Proposed Cockburn Central West Structure Plan - Objection

Proposed Cockburn Central West Structure Plan

Urban Bushland Council WA Inc - Objection

Section 2.4.2.3 Key Wetland Outcomes

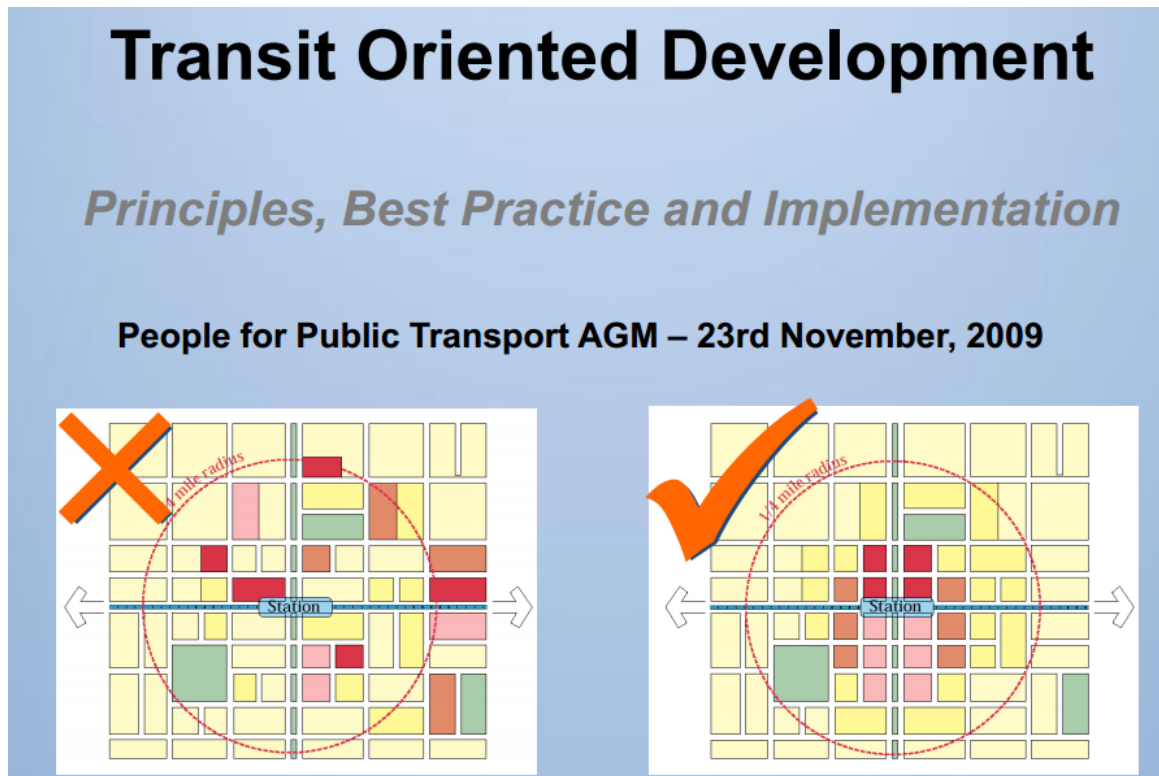
This section lists a number of irrelevant points to justify the filling-in of the existing natural wetland on the site. There can be no justification for filling-in natural wetlands on the Swan Coastal Plain.

The previous point details how the SPP 4.2 specifically refers to Environmentally Sustainable outcomes making this point mute.

Above: “Transit Oriented Development Principles, Best Practice and Implementation” Benjamin Russ of Infracplan (Aust) Pty Ltd, PPT Annual General Meeting 2009.

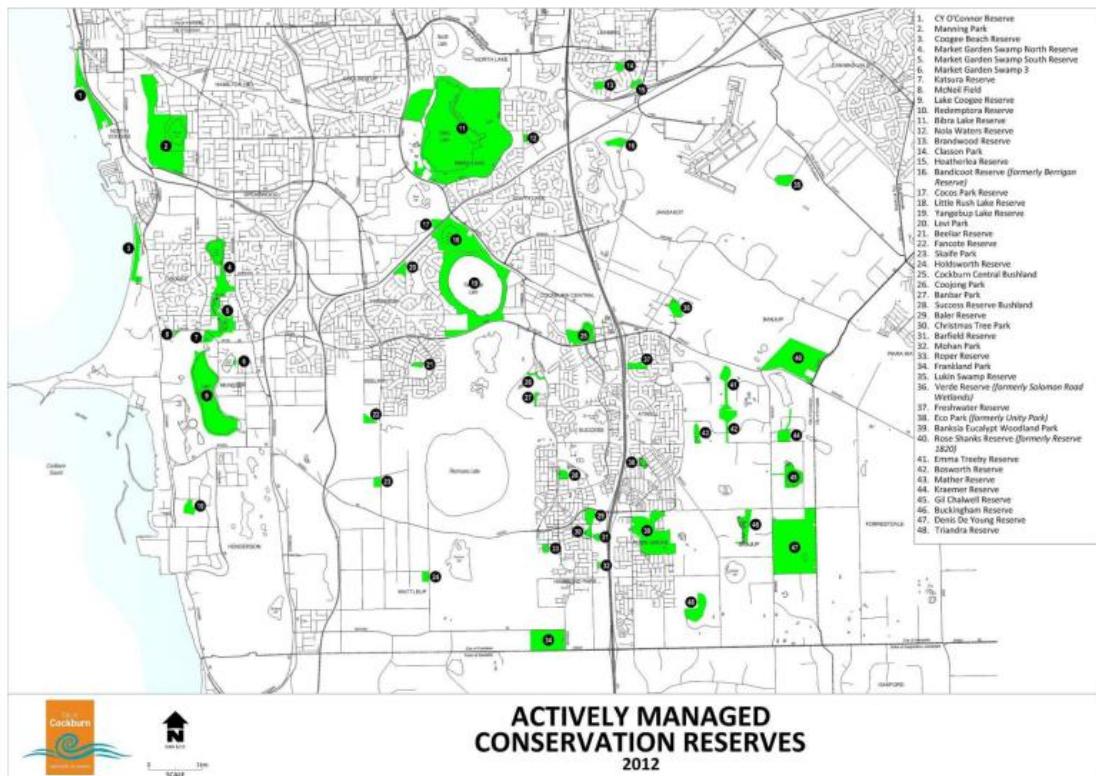
TOD Best Practice Principles do not advocate the destruction of wetlands. Rather they advocate the preservation of significant environmental features (see diagram below, showing green areas preserved within the TOD).

5.2.3 Detention Basin (Feature Lake) Design

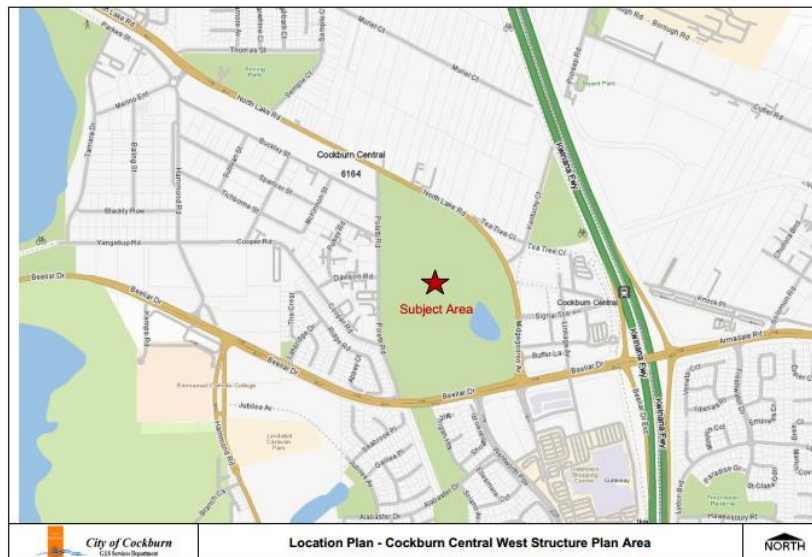
The Proposal to fill in the REW and create an artificial wetland north of the REW is counterintuitive. Land for development should not come at the cost of clearing significant remnant vegetation.

I fail to see the logic in filling an existing REW wetland and attempting to create a wetland 200m further north. Why has this been done when the exiting wetland could be utilised to treat storm water. Has this been done to negate the need to provide a 50 metre buffer around the existing wetland and thus create more developable land?
